<b>REPORT TO:</b>	Kendyll Harper, SWDC [5/5/2021]	<b>CC:</b>
<b>FROM:</b>	David K. Wanty, Wanty Transportation Consultancy; CPEng, M.ITE	
<b>RC200149:</b>	Quarry and trucking operation, Underhill Road, Featherston	
<b>ISSUE DATE:</b>	19/5/2021	<b>REVISED:</b>
		<b>SITE VISIT(S):</b> 12/5/21

This is a peer review for South Wairarapa District Council (SWDC) relating to an Application entitled Proposal to crush and stockpile aggregate by PJ Warren Earthmoving Ltd, relating to an existing site off Underhill Road approximately 3.2 km from SH2 Featherston. The following documents were provided:

Figure 1: Site plan, GWRC report Figure 1, and Council aerial of SH2 at Wakefield St.

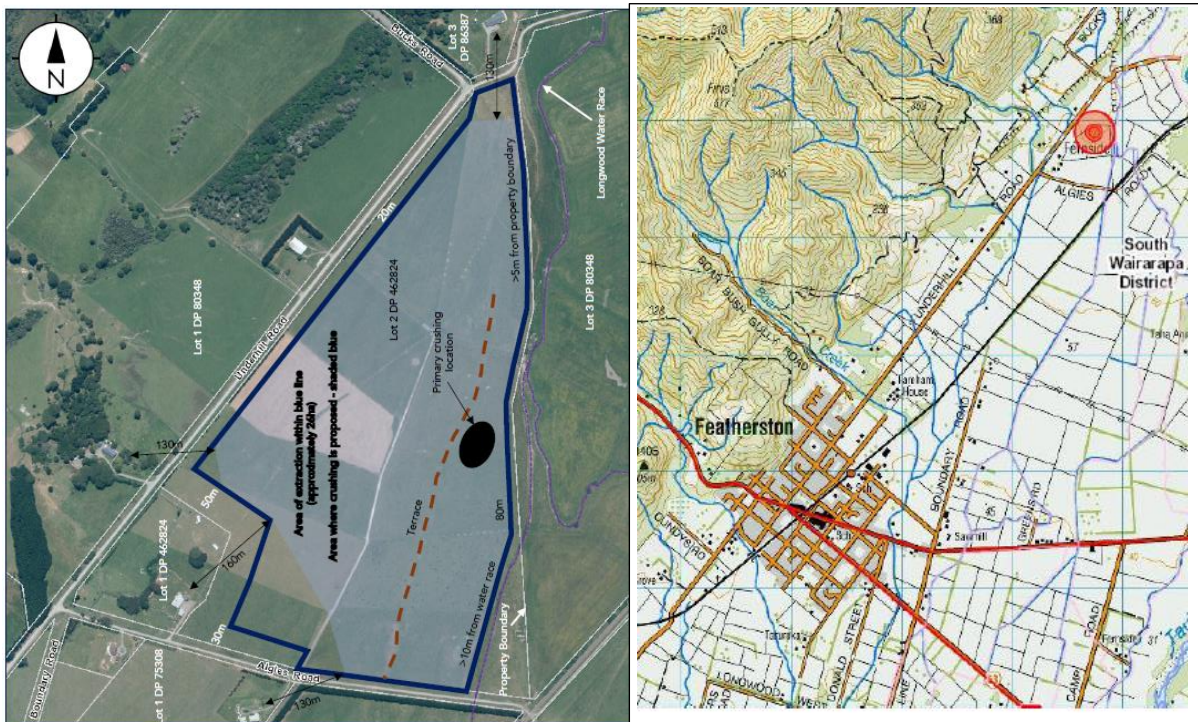
The key issue of concern related to the SH2 intersection with Wakefield St.

The SH2 Fitzherbert Street carriageway is nominally 14.2 m between kerb faces with a nominal 2.5 m flush median provided principally for the right turn into SH53 Revans Street (east) southeast of SH2. There is a portion of Revans Street (west) northwest of SH2 and Wakefield Street which is Stop controlled and on an oblique angle. Wakefield Street carriageway is stated as 11.6 m but was measured by SH2 as 11.9/12.0 m with a 5.7 m northbound lane. SH2 was measured east of Wakefield St as 14.1 m carriageway with a 2.4 m flush median; the eastbound shoulder was 2.7 m and a 3.4 m traffic lane, while westbound shoulder was 1.2 m and 4.4 m traffic lane.

Figure 2: Reported crashes

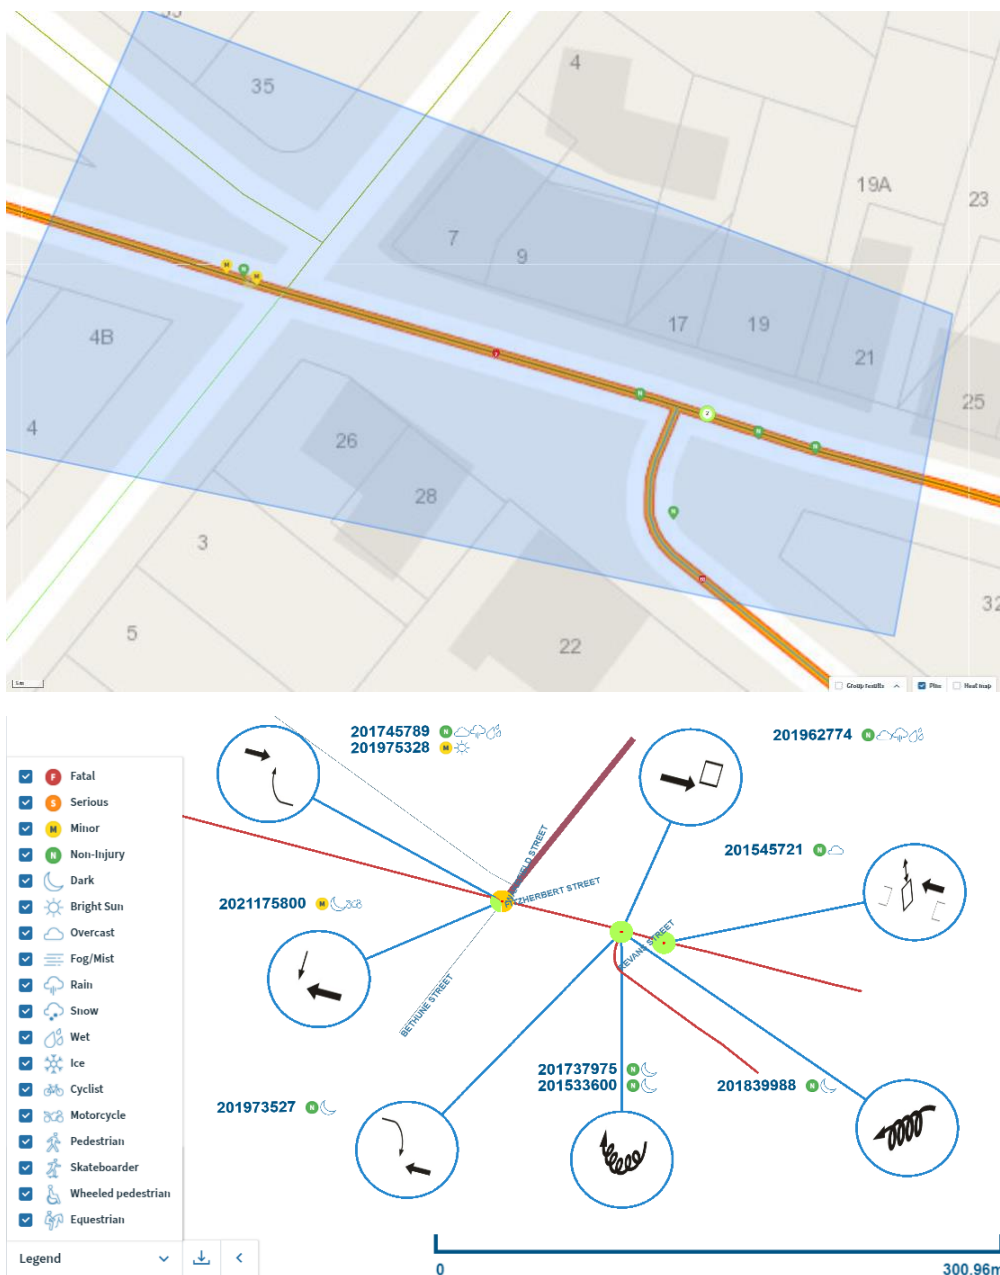
While the crash history was reported in the Traffic Assessment letter report, an examination of the crashes on SH2 in the vicinity of Wakefield Street was undertaken for 2015 to 2020 (plus part 2021 as at 7/5/2021). Grouping by 20 m results in one group of 3, one group of 5 and a single crash east of SH53 for the area as shown below – the collision diagram is also shown.

Figure 6: Level of Service for existing PM survey (top); added development light and heavy traffic (bottom)

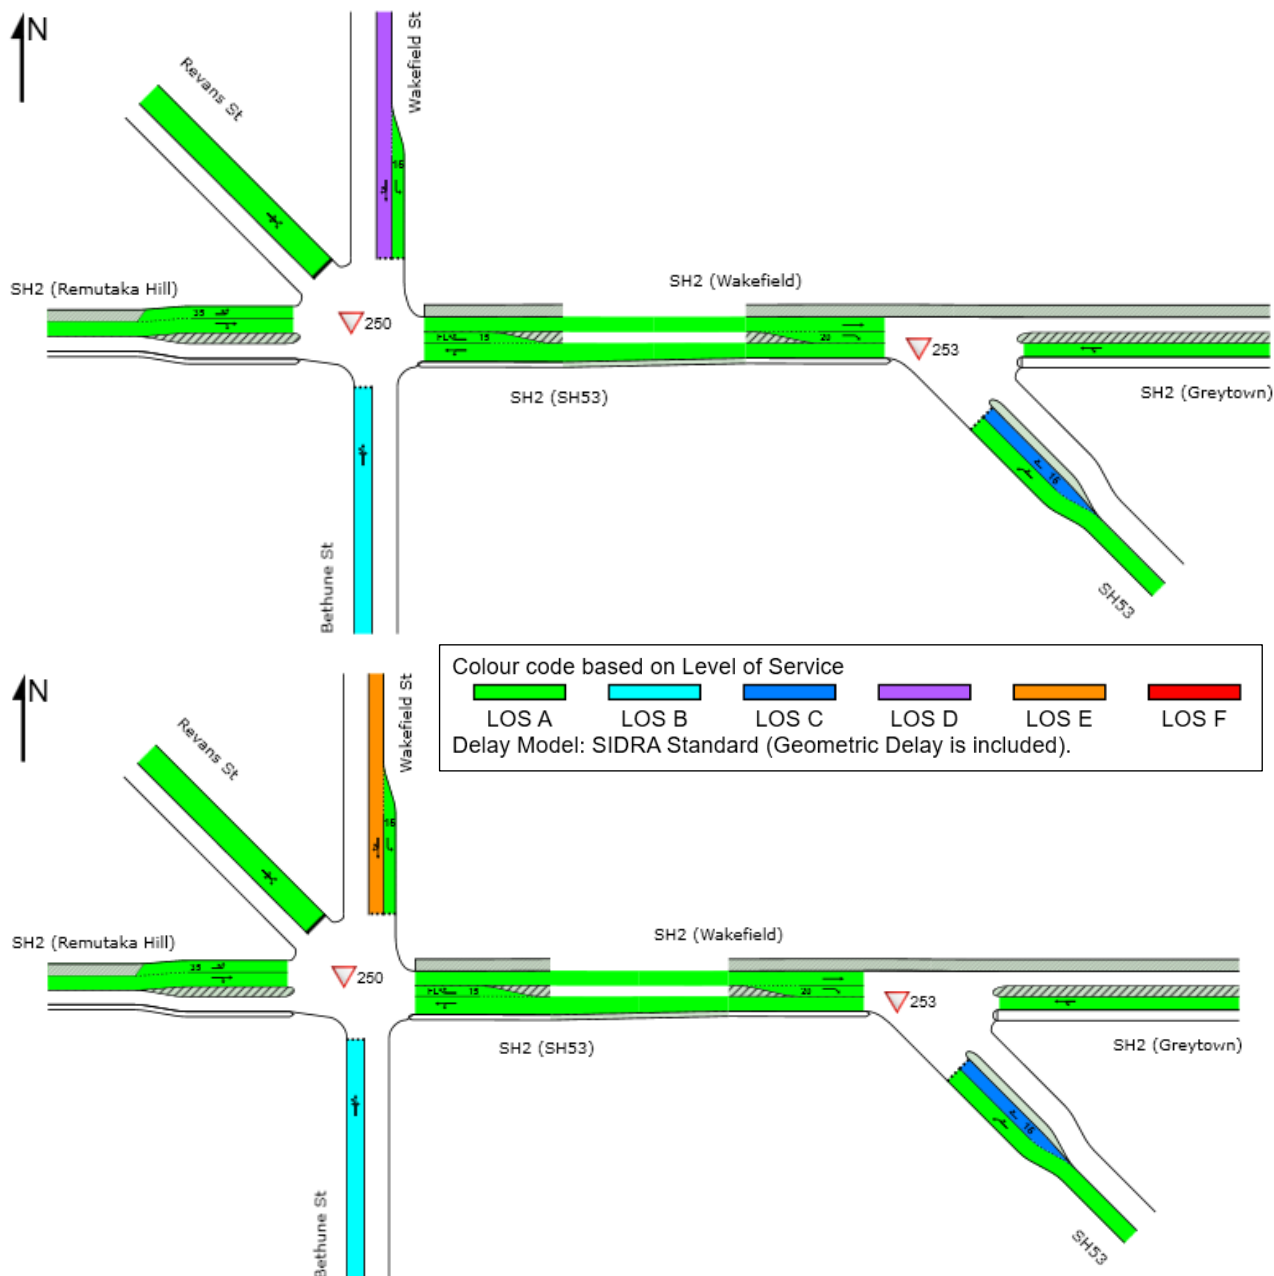
The potential impact of the additional development traffic with a laden truck turn right out of Wakefield St is an increase in the right turn out delay from 26½ (LoS D) to 41 seconds, just beginning LoS E. It is unlikely though that laden trucks would be leaving the quarry at this time to turn right and already a large gap (8 s) is required for even light traffic (SIDRA by default multiplies this by 2.5 for large trucks). Modelling it as a usual truck (default multiplier 1.5 ) results in a 31½ second delay (LoS D) which is considered more realistic.

Accordingly based on the surveyed traffic flows, probably higher than the usual before 5 pm flows, the quarry operation impact on the SH2 Wakefield Street intersection during the critical weekday late afternoon period is likely to be no more than minor based on current year flows. With respect to future flows allowing for a potential increase in SH2 traffic of 10% somewhat surprisingly appears not to affect the right turn out delay noting that reduction in the gap for increased opposing flow has not been applied (the default).
